September 2015 Technical Service

**Service Action: Replace Automatic Recirculation Sensor**

F25 (X3)

F26 (X4)

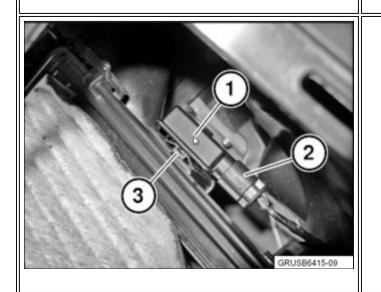
- Remove the cover and seal in order to access the micro filter. REP 64 31 105 "Removing and installing / replacing right micro filter housing cover".
- Remove filter cover (1) in direction of arrow as shown.

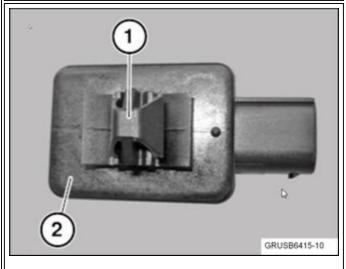
- Unfasten plug connection (2) and disconnect.
- Unlock retaining tab (1) and remove AUC sensor.

- Retaining tab (1) on AUC sensor (2) must not be damaged.
- The AUC sensor must be pointing downwards.
